DEVELOPMENT REVIEW BOARD
Code Enforcement Comments

DRB PROJECT NUMBER:
PR-2022-006926
PS-2022-00088 – SKETCH PLAN

PROJECT NAME:
PROFESSIONAL SURVEYING LLC agent for VINCENT SANCHEZ requests the aforementioned action(s) for all or a portion of: **TRACT 291 A & B, MRGCD MAP 38 AND LOTS 17 & 18, PUEBLO BONITO ADDITION** zoned **X, located at 2514 & 2518 CARSON RD NW & 2429 PUEBLO BONITO CT NW** containing approximately X acre(s). (J-13)

PROPERTY OWNERS: SANCHEZ VINCENT & REBECCA
REQUEST: REPLAT 4 LOTS

7. For lots fronting Carson Rd NW:

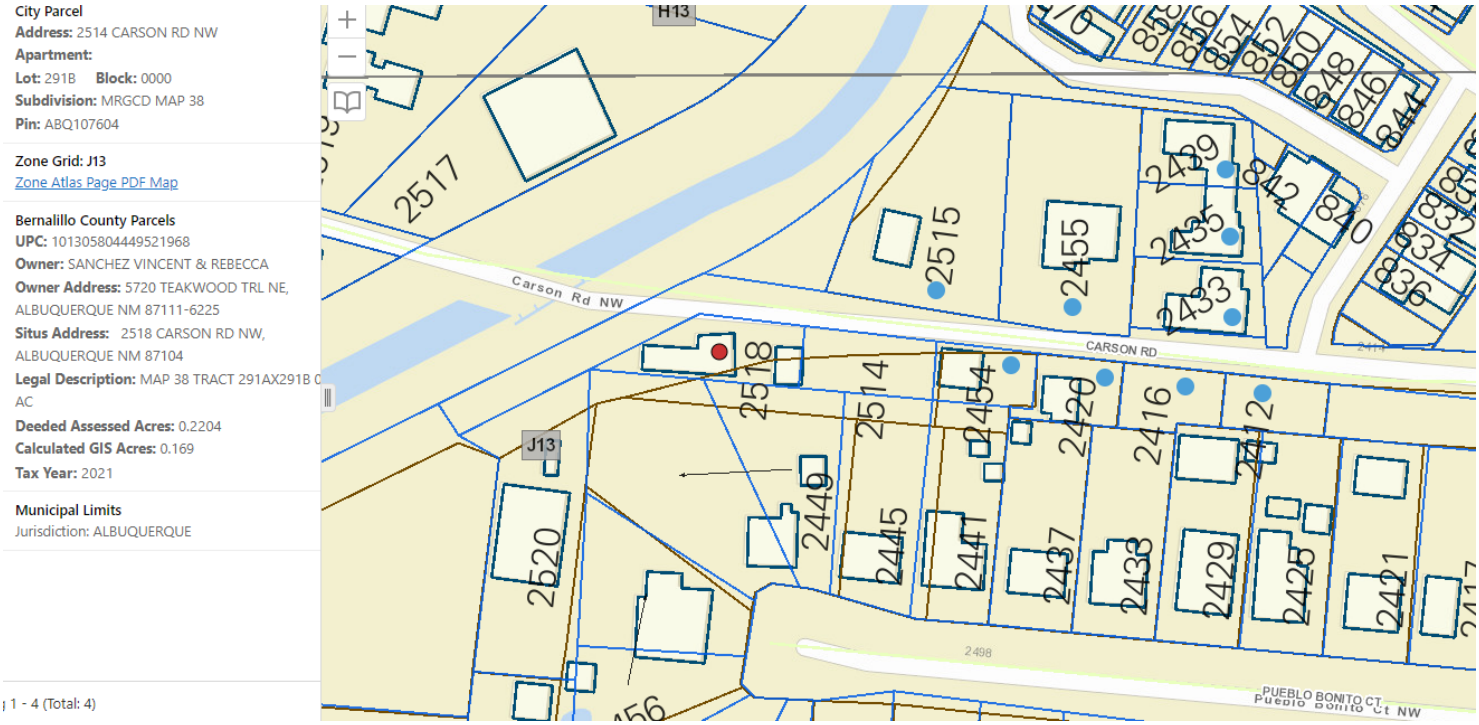
Average lot size in block area = 0.1387 acre
Minimum allowed lot size (75%) = 0.1040 acre
Maximum allowed lot size (125%) = 0.1734 acre
See map below, showing properties included in block area for calculations of average.

Proposed Lot 2 = 0.1342 acre = within allowed contextual lot size
Proposed Lot 1 = 0.902 acre = lower than allowed minimum contextual lot size of 0.1040 acre
You must obtain an approved Variance from the Zoning Hearing Examiner (ZHE) prior to replat.

8. For lots fronting Pueblo Bonito Ct NW:

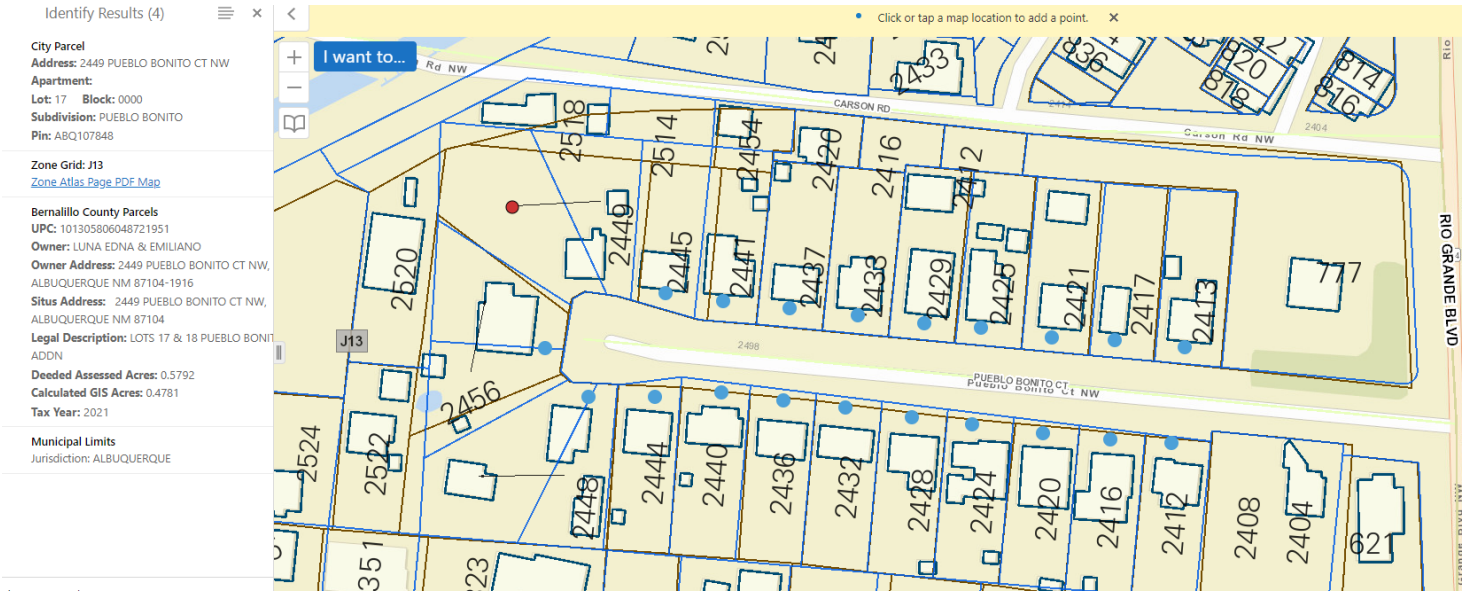
Average lot size in block area = 0.2351 acre
Minimum allowed lot size (75%) = 0.1763 acre
Maximum allowed lot size (125%) = 0.2939 acre

See map below, showing properties included in block area for calculations of average.

Proposed 17A = 0.1836 acre = within allowed contextual lot size
Proposed 18A = 0.3103 acre = higher than allowed maximum contextual lot size of 0..2939 acre
You must obtain an approved Variance from the Zoning Hearing Examiner (ZHE) prior to replat.
